APPLICATION NO.	FILING DATE	FIRST NAMED INVENTOR	ATTORNEY DOCKET NO.	CONFIRMATION NO.
10/734,999	12/12/2003	Eugene Marsh	MI22-2461	1993

Office Action Summary	Application No. 10/734,999	Applicant(s) MARSH ET AL.	
	Examiner Khanh B. Duong	Art Unit 2822

DETAILED ACTION

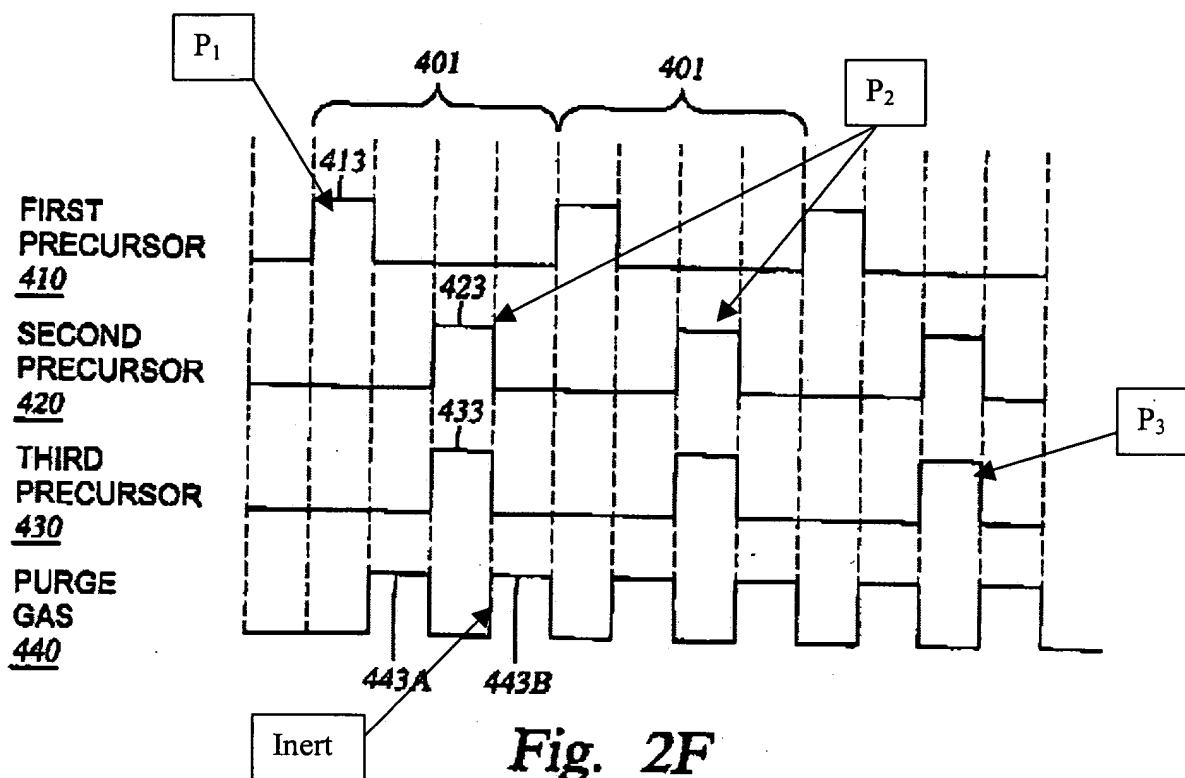
Re claim 52, Yang et al. ("Yang") expressly discloses in Fig. 2F [see illustration below] a deposition method comprising: positioning a semiconductor substrate within a deposition chamber; flowing a first precursor gas 410 within the deposition chamber to form a first monolayer on the substrate; after forming the first monolayer on the substrate, flowing a second precursor gas 420 different in composition from the first precursor gas 410 within the deposition chamber to form a second monolayer on the first monolayer, said second precursor gas 420 flowing comprising a plurality of time spaced second precursor gas pulses 423; and after forming the second monolayer on the substrate, flowing a third precursor gas 430 different in composition from the second precursor gas 420 within the deposition chamber to form a third monolayer on the substrate, the third precursor 430 being different in composition from the first precursor 410.

Re claim 54, Yang expressly discloses in Fig. 2F at least one period of time between two adjacent second precursor gas pulses 423 when some gas (410 or 440) is fed to the chamber.

Re claim 55, Yang expressly discloses in Fig. 2F at least one period of time between two adjacent second precursor gas pulses 423 within which at least one inert purge gas pulse 443B is fed to the substrate within the chamber.

Re claims 59 and 60, Yang expressly discloses in Fig. 2F the plurality of time spaced second precursor gas pulses 423 being two, and comprising a period of time between said two when some gas (e.g. first precursor 413 and inert gas 443B) is fed to the chamber.

Re claims 61 and 62, Yang expressly discloses in Fig. 2F flowing multiple inert purge gas pulses 443A to the substrate within the chamber intermediate the first precursor flowing 413 and the third precursor flowing 433.

Re claim 63, see discussion above regarding claim 52. In addition, Yang expressly discloses in Fig. 2F the second precursor gas flowing comprising at least two time abutting second precursor gas pulses which are characterized by different flow rates of the second precursor (relative to the flow rates of the first precursor).

Re claim 64, Yang expressly discloses in Fig. 2F the two time abutting second precursor gas pulses 423 are equal in time.
